Jericho Wind, Inc.

Revision to the Design and Operations Report – Jericho Wind Energy Centre

60301207

September, 2013

Figure 2-1

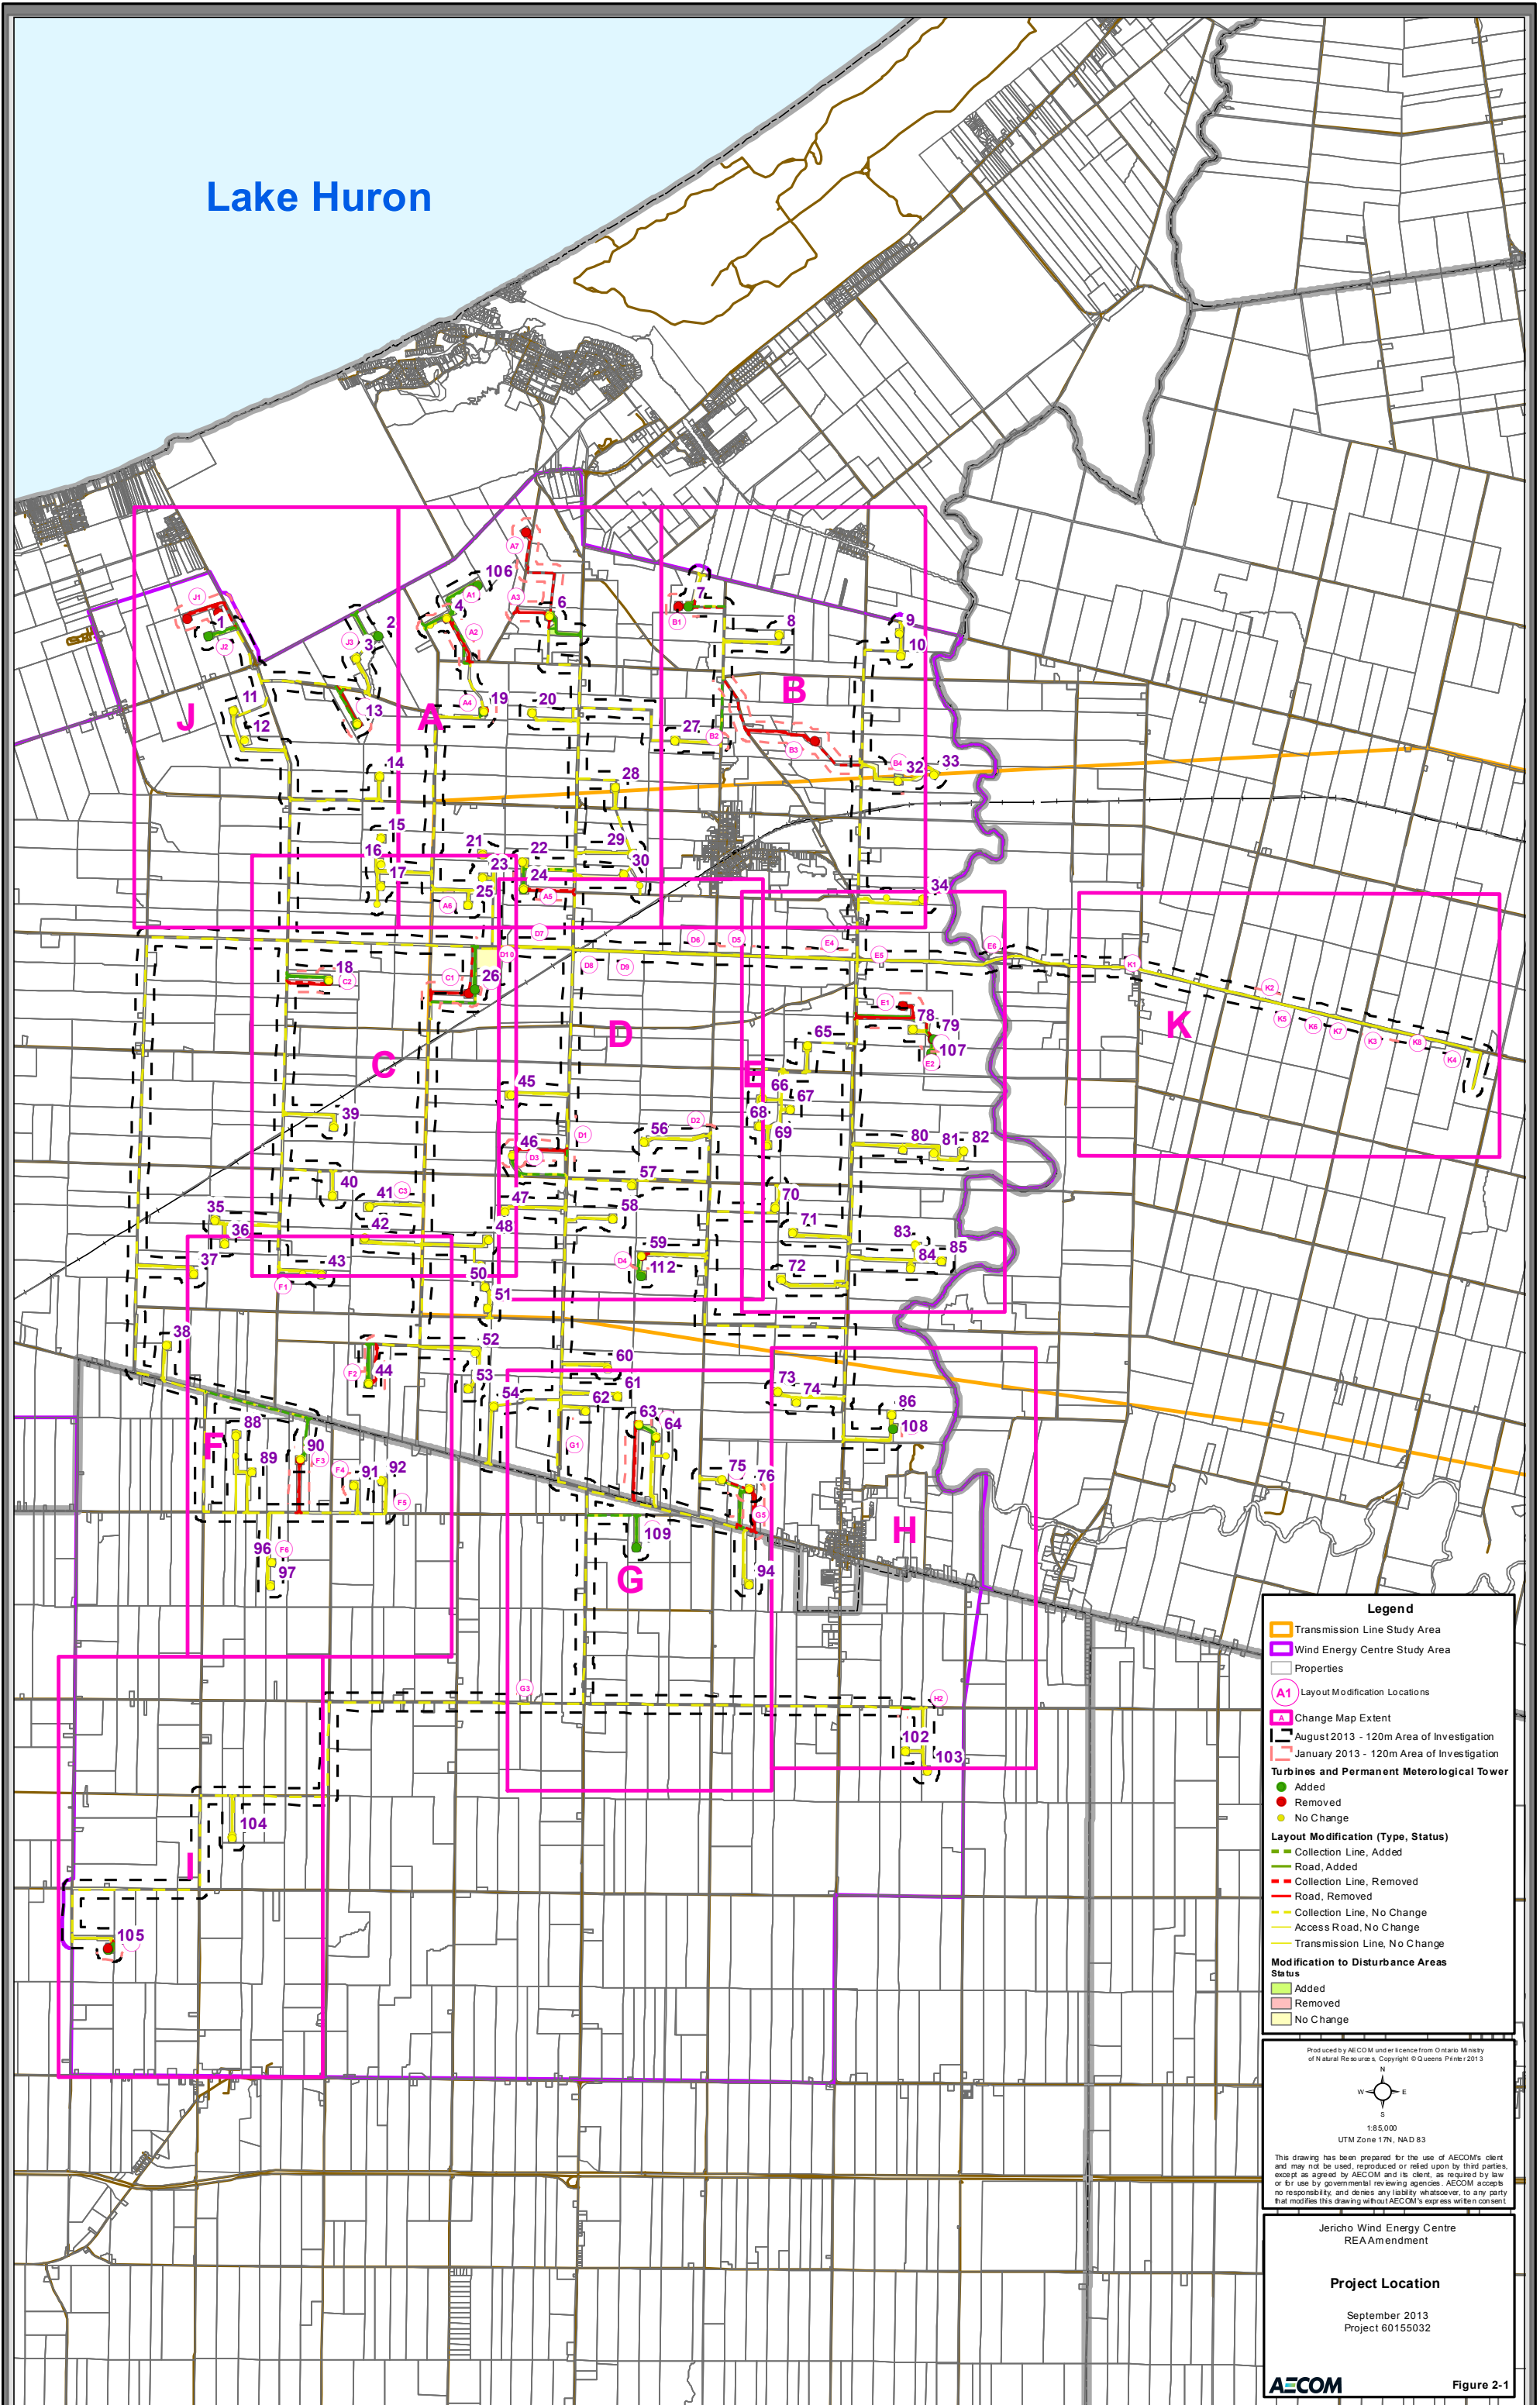
Figure 2-1 illustrates the modified Project Location. **Appendix A** contains a series of figures showing the details for each of the modifications.

Label on Figure 2-1	Proposed Modification	Rationale for Proposed Modification	New Potential Environmental Effects	New Mitigation Measures (Mitigation measures not included in the original REA are shown in <i>italicized bold</i>)
A1	Addition of Turbine 106 and associated access road and collection line, extending north east from Turbine 4.	Infrastructure or construction disturbance area added or changed to optimize project design/ constructability.	<p><u>Natural Heritage:</u></p> <ul style="list-style-type: none"> Access road is 24 m from a new Rare Vegetation Community Feature RVC-05 not previously described in the NHA. There are no potential effects to this feature associated with the access road during operation. Access road and collection line are within 120 m of new Generalized Candidate Significant Wildlife Habitat Feature (Insect Species of Conservation Concern Habitat, Plant Species of Conservation Concern Habitat, and Red-headed Woodpecker Habitat) in Natural Area 290, not previously described in the NHA. There are no potential effects on this feature associated with the access road and collection line during operation. <p><u>Water Bodies:</u></p> <ul style="list-style-type: none"> Effects associated with new crossing of a water body (Feature ID R4.16-D) include: <ul style="list-style-type: none"> Increase in impervious surfaces from presence of turbine foundation and access roads, resulting in increased water temperatures, increased surface runoff and stream peak flows, and reduced infiltration, base flows and upwelling. Soil/water contamination by oils, grease and other materials from accidental spills and release of contaminants from equipment. Obstruction of lateral flows in watercourses and other water bodies due to design of culverts and debris build-up at water crossings. 	<p><u>Natural Heritage:</u></p> <ul style="list-style-type: none"> N/A <p><u>Water Bodies:</u></p> <ul style="list-style-type: none"> Regularly maintain vehicles and other equipment. Minimize vehicle traffic on exposed soils and sensitive slopes. Locate facilities where contaminants are handled at least 30 m away from water bodies. Develop and implement an erosion and sediment control plan. Develop a spill response plan. Control soil / water contamination through best management practices. Design culverts to accommodate high flows of the watercourse. Inspect culverts during routine maintenance activities for buildup of debris.

A2	Relocation of access road to Turbine 4 to travel north east from Jericho Road, and relocation of collection line to Turbine 4 near Kennedy Line.	Construction disturbance area modified to reduce or eliminate impacts to archaeological resources.	None – no new natural heritage or water body features within 120 m; area previously studied for cultural heritage.	N/A
A3	Relocation of access road and collection line to Turbine 6 to travel west from Northville Road and then north to Turbine 6; relocation of Turbine 6 construction disturbance area to the north.	Construction disturbance area modified to reduce or eliminate impacts to archaeological resources.	None – no new natural heritage or water body features within 120 m; area previously studied for cultural heritage.	N/A
A4	Relocation of Turbine 19 construction disturbance area 19 m to the southwest and addition of access road construction disturbance area near Jericho Road.	Construction disturbance area modified to reduce or eliminate impacts to archaeological resources.	None – no new natural heritage or water body features within 120 m; area previously studied for cultural heritage.	N/A

A5	Removal of access road and collection line to Turbine 24, addition of access road disturbance area between Turbine 22 and Turbine 24 and relocation of collection line to the access road disturbance area for Turbine 22.	Infrastructure or construction disturbance area added or changed to optimize project design/ constructability.	None – no new natural heritage or water body features within 120 m; area previously studied for cultural heritage.	N/A
A6	Removal of a portion of construction disturbance area for access road and collection line to Turbines 21, 23 and 25.	Construction disturbance area modified to reduce or eliminate impacts to archaeological resources.	None – no new natural heritage or water body features within 120 m; area previously studied for cultural heritage.	N/A
A7	Removal of Turbine 5 and associated access road and collection line.	Turbine and associated infrastructure removed.	None – no new natural heritage or water body features within 120 m; area previously studied for cultural heritage.	N/A

B1	Relocation of Turbine 7 and associated construction disturbance area 148 m to the east.	Infrastructure or construction disturbance area added or changed to optimize project design/ constructability.	None – no new natural heritage or water body features within 120 m; area previously studied for cultural heritage.	N/A
B2	Addition of collection line in Gordon Road right-of-way, north of the road to Turbine 27.	Infrastructure or construction disturbance area added or changed to optimize project design/ constructability.	<p><u>Natural Heritage:</u></p> <ul style="list-style-type: none"> Collection line is within 120 m of new Generalized Candidate Significant Wildlife Habitat Feature (Plant Species of Conservation Concern Habitat and Red-headed Woodpecker Habitat) in Natural Area 233, not previously described in the NHA. There are no potential effects on this feature associated with the collection line during operation. 	<p><u>Natural Heritage:</u></p> <ul style="list-style-type: none"> N/A

B3	Removal of Turbine 31 and associated access road and collection line.	Turbine and associated infrastructure removed.	<p><u>Natural Heritage:</u></p> <ul style="list-style-type: none"> Amphibian Woodland Breeding Habitat Feature AWO-16 in Natural Area 250 was changed to Generalized Candidate Significant Wildlife Habitat because it is more than 120 m away from a proposed access road. There are no potential effects on this feature associated with operation of the project. 	N/A
B4	Addition of Turbine 32 construction disturbance area 34 m to the north and removal of the southeast portion of construction disturbance area.	Construction disturbance area modified to reduce or eliminate impacts to archaeological resources.	None – no new natural heritage or water body features within 120 m; area previously studied for cultural heritage.	N/A
